U.S. Department
of Transportation
**Federal Aviation
Administration**

June 8, 2022

Option B Preliminary Assessment Summary

Additional Information within the Proposal

Figure 1. Roundtable Map

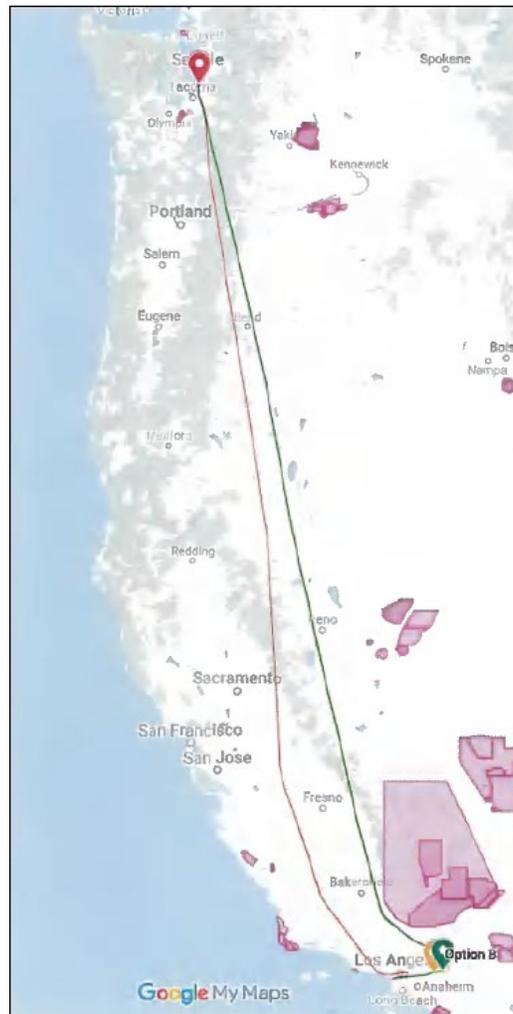
The Proposal would move the aircraft inbound to LAX east of the current flight path by approximately 108 nautical miles (not including any departure airport routing requirements or radar vectors for arrival sequencing). Aircraft would then be sequenced with the ANJLL STAR traffic near the point where Los Angeles Air Route Traffic Control Center (ZLA) would hand off aircraft to Southern California Terminal Radar Approach Control (SCT). Typically, this sequencing is done by ZLA before the aircraft is transferred to SCT. Figure 1 was taken from page 12 of the Proposal. It shows the current flight path (red) and the Roundtable's proposed flight path (green).

From examining the graphics within the Proposal (see Figure 1), it appears that the Proposal had no particular routing of aircraft other than a direct line drawn to a point west of the Edwards AFB R-2508 Complex and east of the current path. There was no description of how this new routing would join the current ANJLL STAR. We utilized the graphic provided by the Roundtable and made our best conjecture, shown in Figure 19, as to how this route relocation could potentially be realized. To effectively assess the data within the Proposal, we broke the route into segments, as we found it easier to evaluate when presented in this way.

Figure 2. Blend Angles of Core Turbojet Flows and Option B to LAX

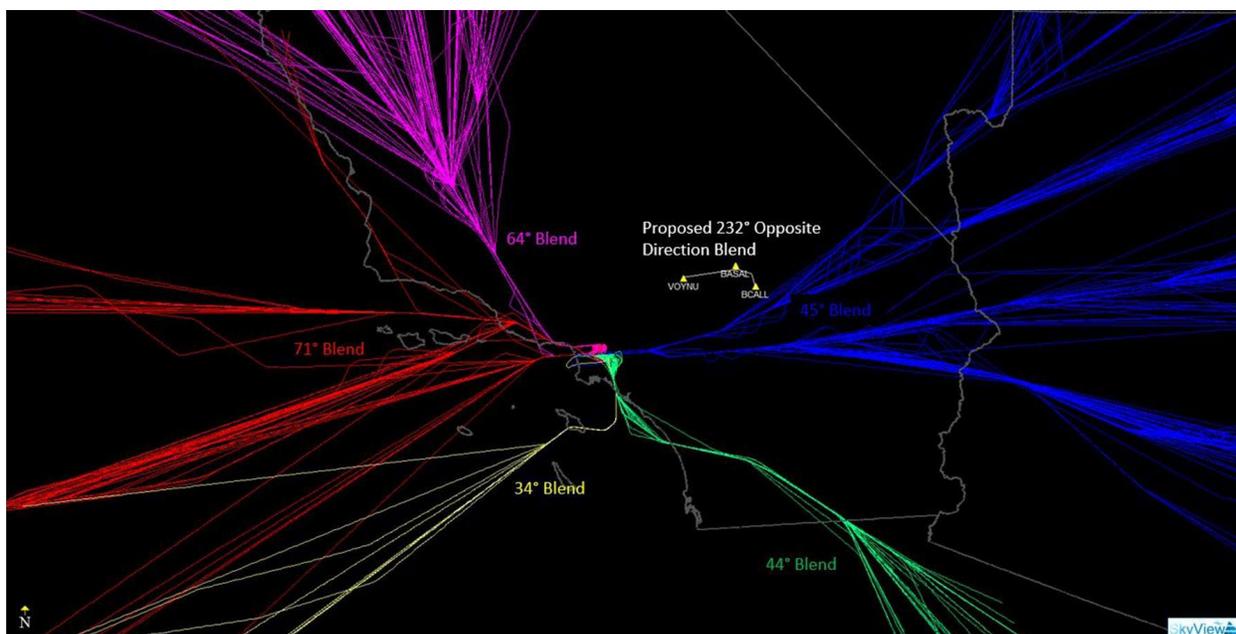
Because the enroute environment relies on a more strategic approach, the blend angle that feeds the common merge point is typically a wedge, incorporating an angular difference between 45° and 90° . Figure 2 illustrates the approximate blend angle for the five core turbojet wedge flows into LAX, along with the blend angle of the Proposal. Again, this manner of opposite direction high altitude blend (232°) is not a standard operating procedure at any other busy location in the NAS—it simply cannot be expected to mirror the downwind-to-base-to-FAC track reversal at LAX.

Figure 3. Sequencing Point of Proposal and ANJLL STAR Route Arrivals

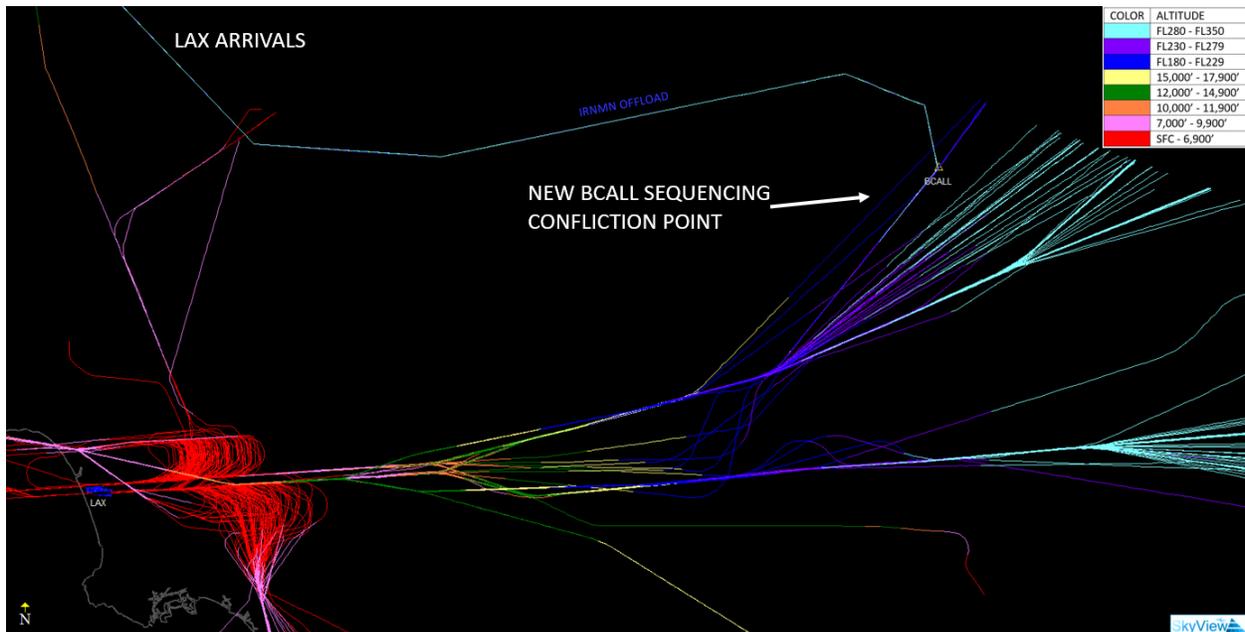
Figure 3 shows where LAX arrivals on the proposed route would need to be sequenced with other ANJLL arrivals. Joining the ANJLL procedure at this angle would most likely require radar vectors to safely sequence the off-loaded traffic.

Figure 4. Proposal and LAX Departures Confliction Point

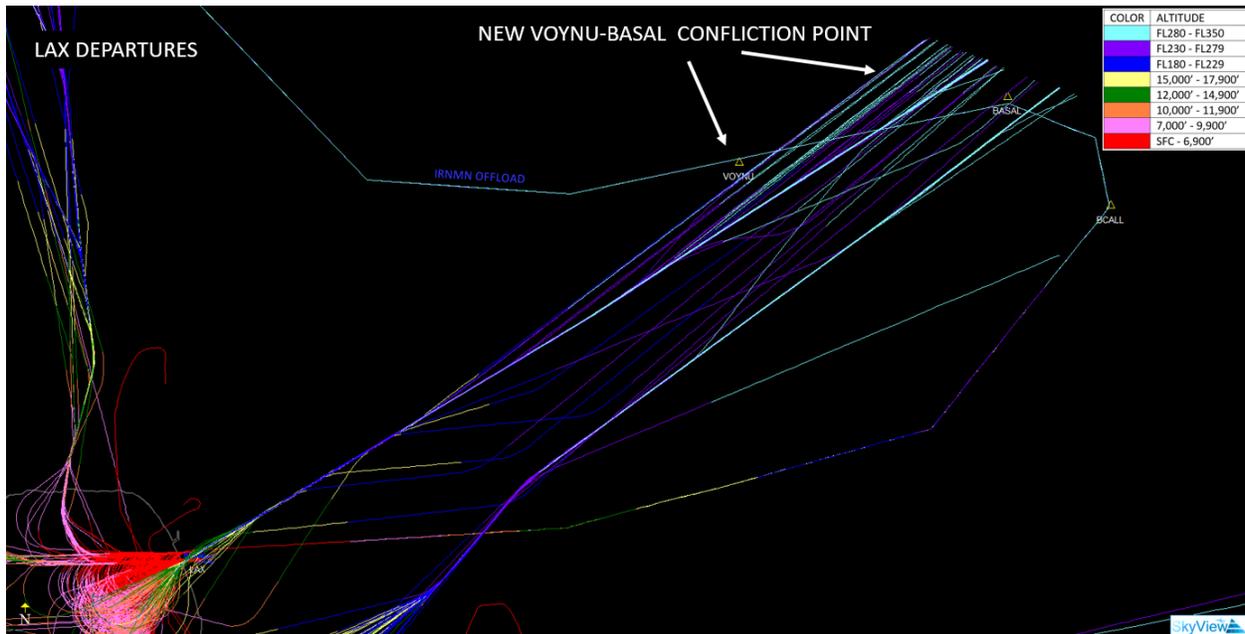
Figure 4 shows the proposed route conflicting with LAX departure aircraft at similar altitude stratum. Procedural separation would require that either arrivals cross VOYNU waypoint at a lower altitude to allow the departure traffic to get above the proposed route, or the departure procedures stop their climb at a lower altitude until clear of the proposed route.

Figure 5. Proposal with BUR Arrivals

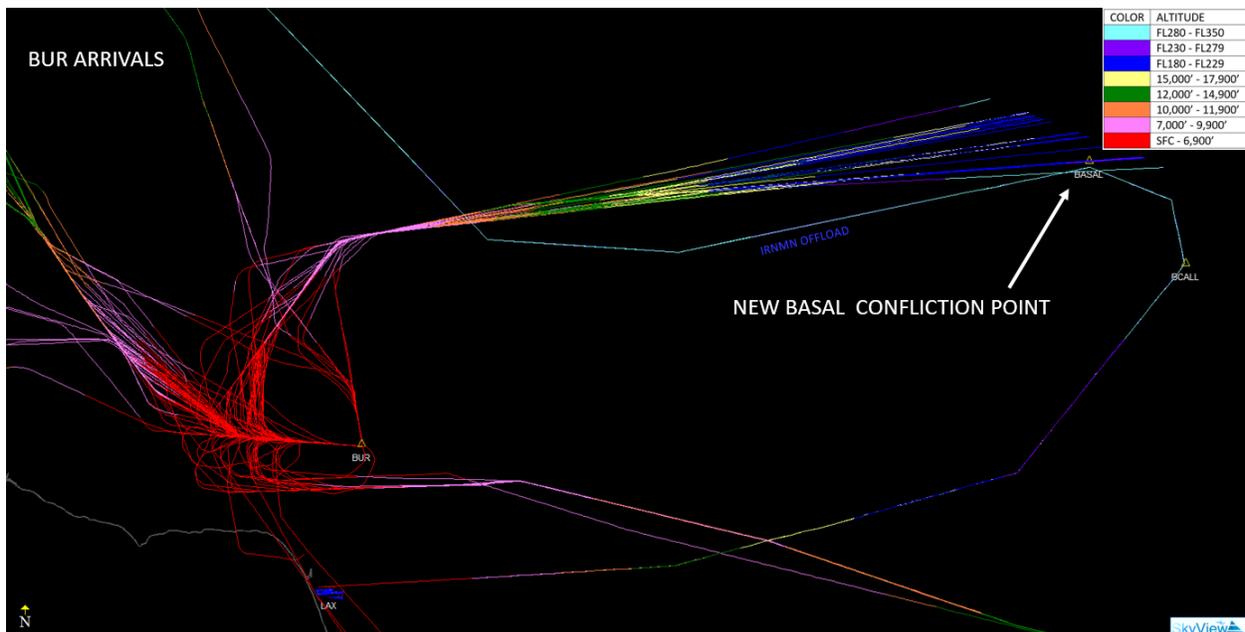
Figure 5 shows that Hollywood-Burbank Airport (BUR) arrivals currently remain north of ANJLL arrivals. The proposed route would place both those ANJLL arrivals and BUR arrivals in the same altitude stratum.

Figure 6. Proposal with BUR Departures

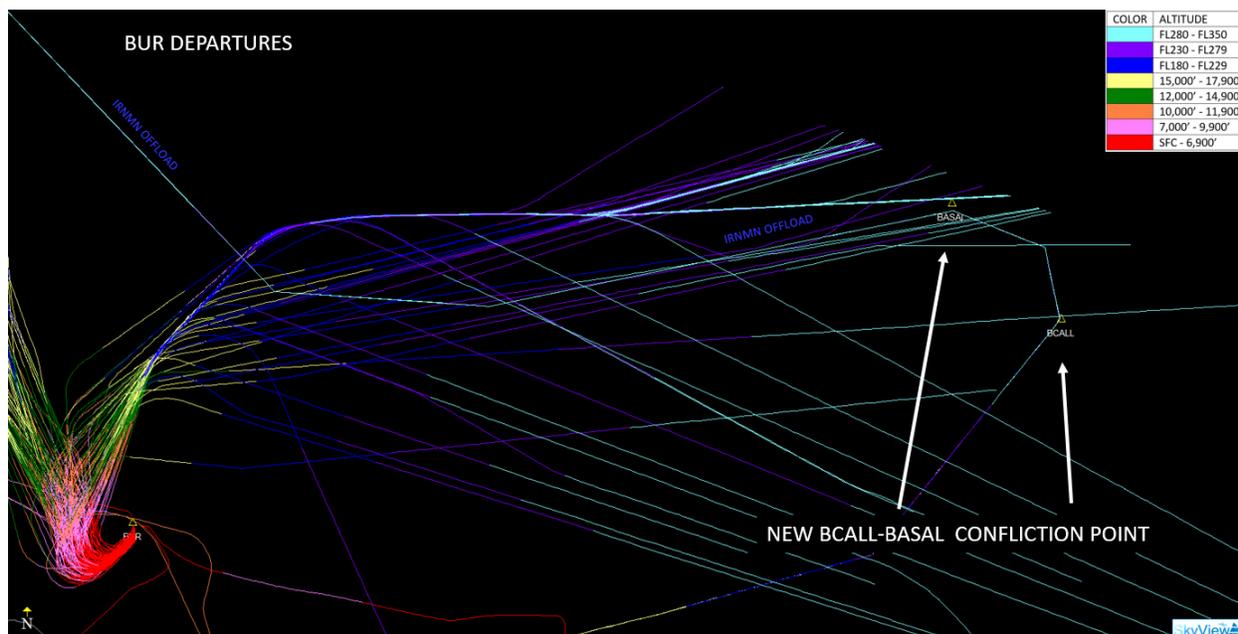
Figure 6 shows that BUR departures would cross the proposed route, necessitating a stop in their departure climb and a stop in the descent of aircraft on the proposed route.

Figure 7. Proposal with LGB Departures

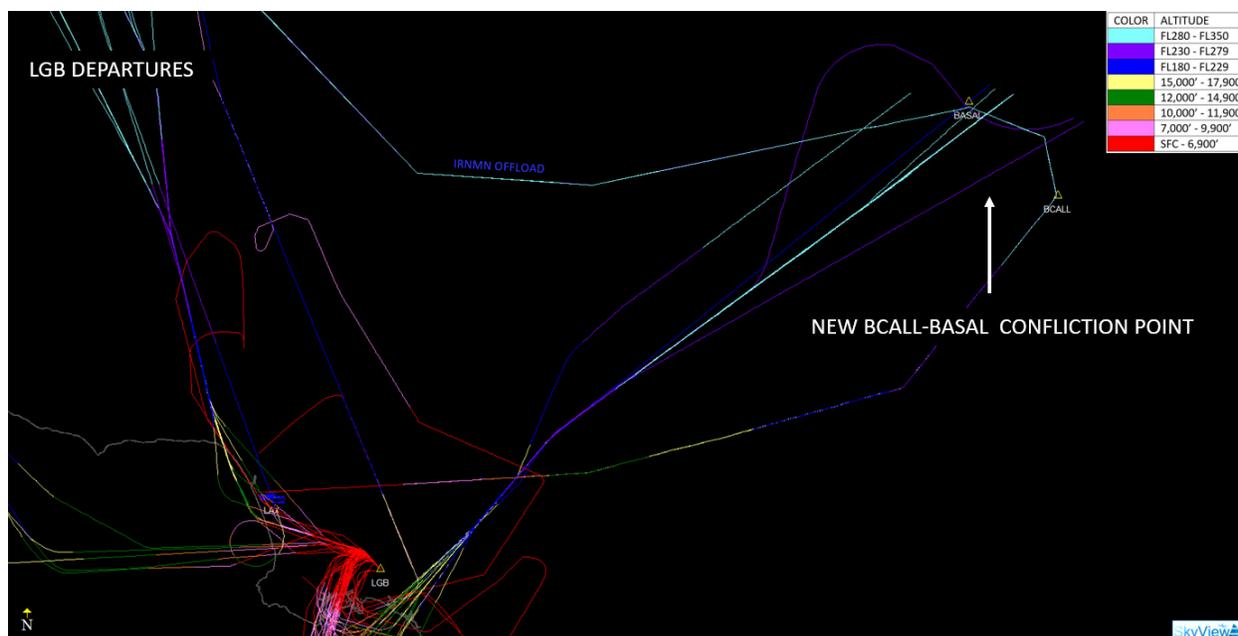
Figure 7 shows that Long Beach Airport (LGB) departures would need to be stopped below the proposed route, creating a potential conflict with BUR departures stopped at similar altitudes.

Figure 8. Proposal with ONT Arrivals

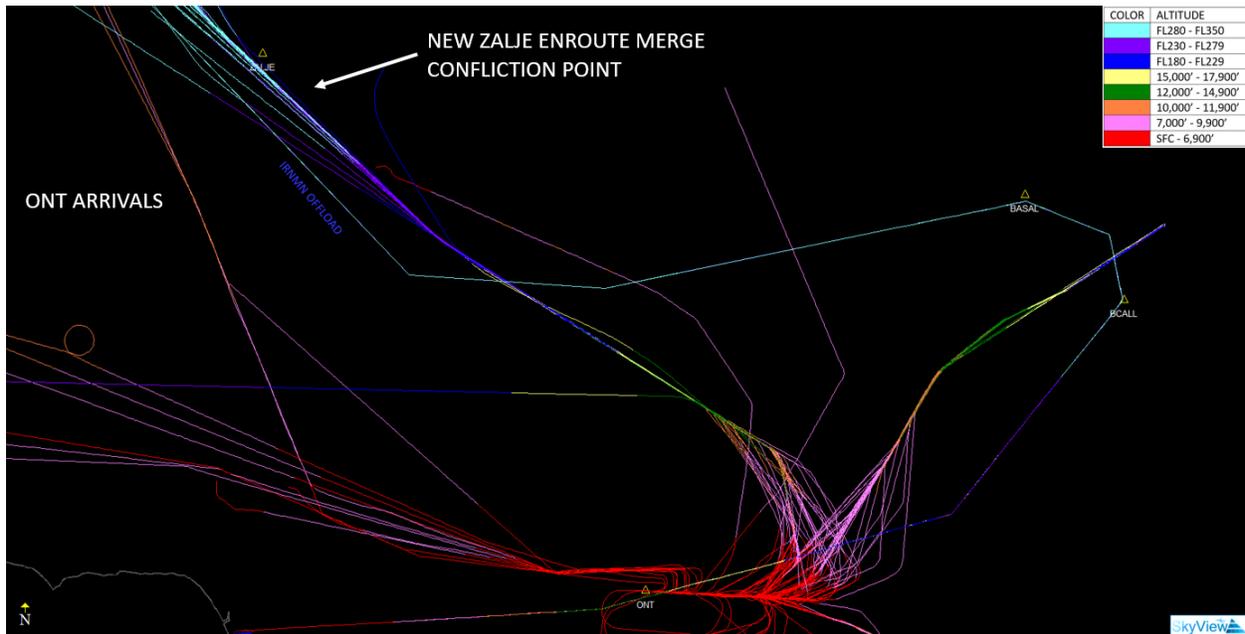
Figure 8 shows that Ontario International Airport (ONT) arrivals would need to be sequenced with the proposed route aircraft.

Figure 9. Proposal and ONT Departures

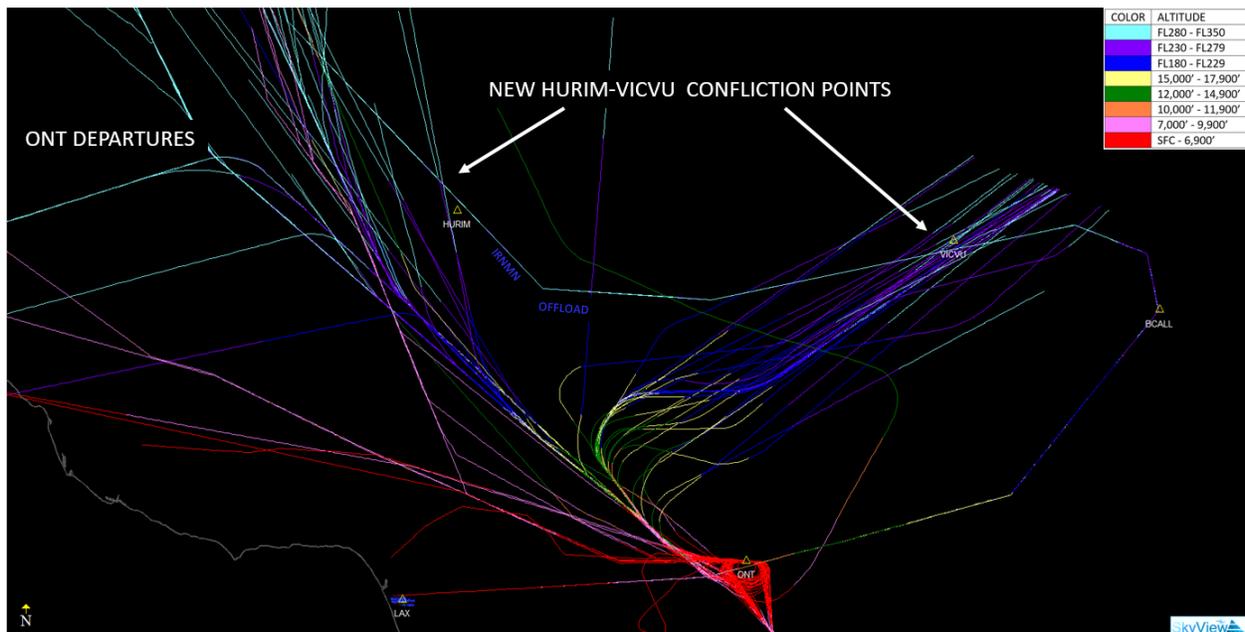
Figure 9 shows that ONT departures would need to be stopped below the proposed route aircraft at both the HURIM and VICVU confliction points. Other potential impacts are possible as a result of BUR and LGB departures being stopped at similar altitudes.

Figure 10. Proposal and PSP Arrivals

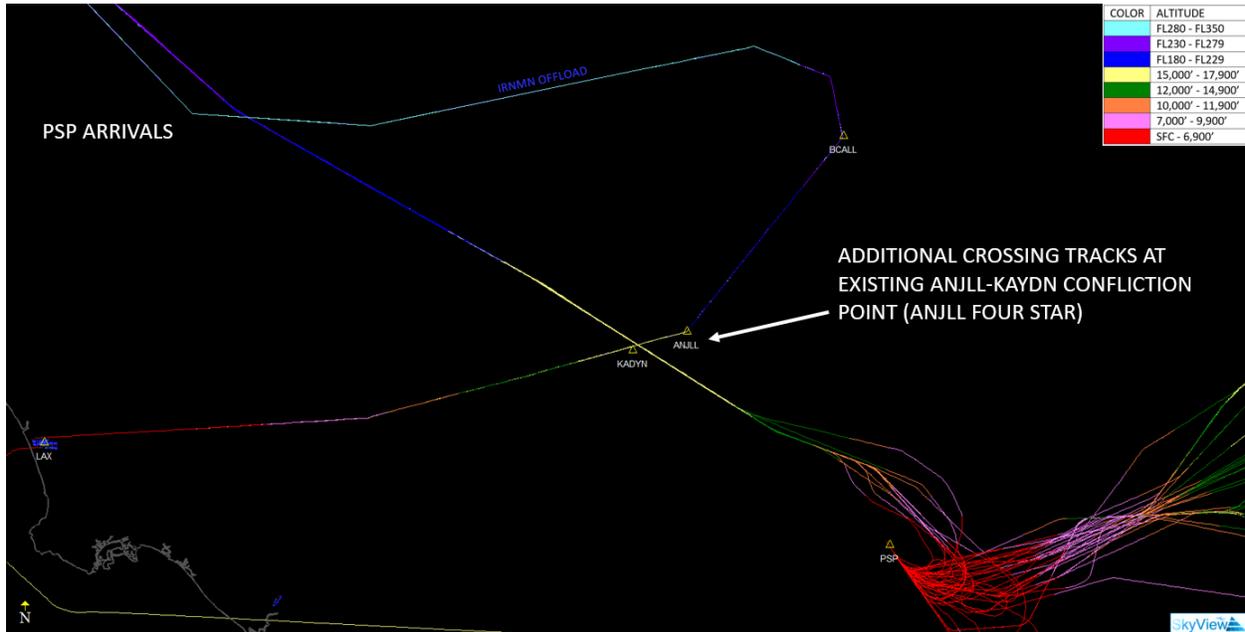
Figure 10 shows that conflicts with Palm Springs International Airport (PSP) arrivals near KAYDN would increase with the addition of aircraft on the proposed route.

Figure 11. Proposal and PSP Departures

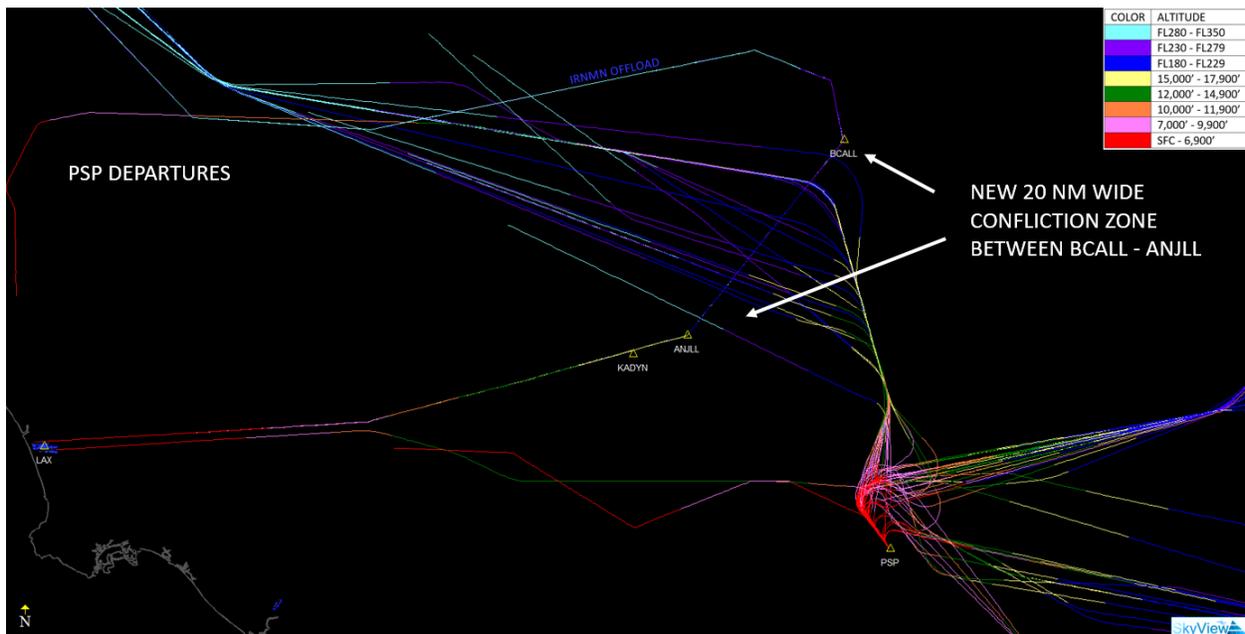
Figure 11 shows that PSP departures would need to be stopped for the proposed route aircraft. Additionally, the northern departure route may not be feasible due to inbound traffic crossing near BCALL.

Figure 12. Proposal and SAN Departures

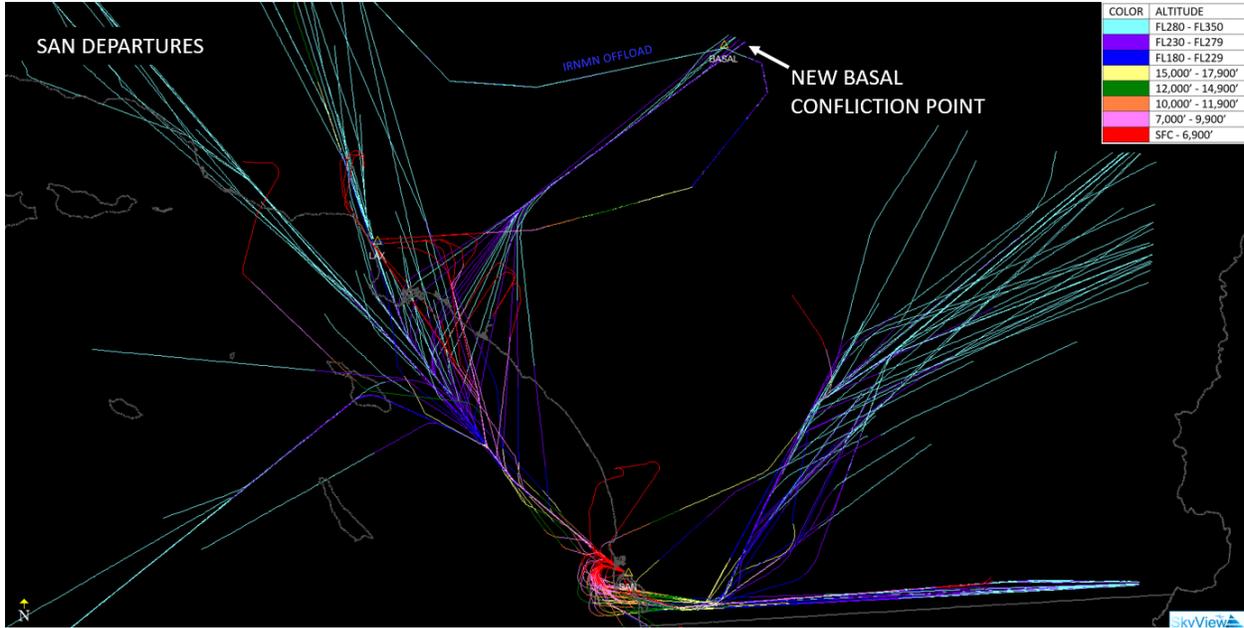
Figure 12 shows that San Diego International Airport (SAN) departures would need to be stopped at lower altitudes for the proposed route aircraft, potentially conflicting with BUR/LGB

departure traffic. SAN arrivals tend to be above LAX arrivals, however, and should have no significant impact as arrivals merge.

Figure 13. Proposal and SBD Arrivals

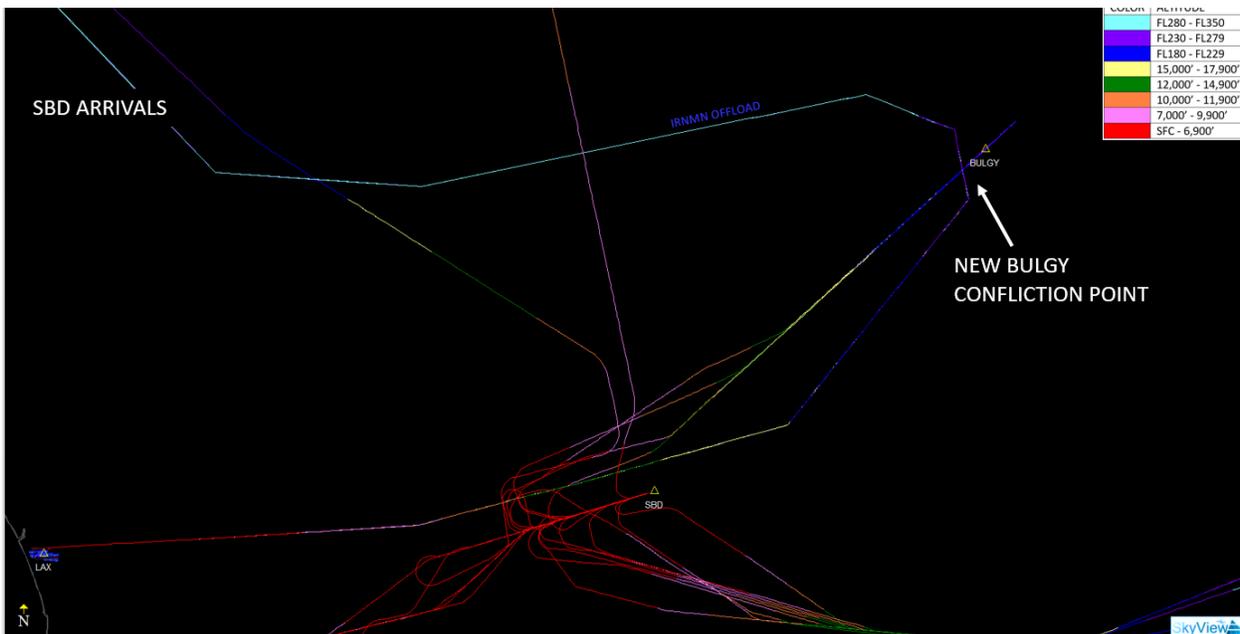
Figure 13 shows that San Bernardino International Airport (SBD) arrivals would need to be sequenced, to some extent, with the proposed route aircraft—they could be pushed lower, but then they would conflict with LGB/BUR/SAN departures. No new conflicts with SBD departures were identified with the proposed route aircraft, although there could be an issue with LGB/BUR/SAN departures stopped at lower altitudes.
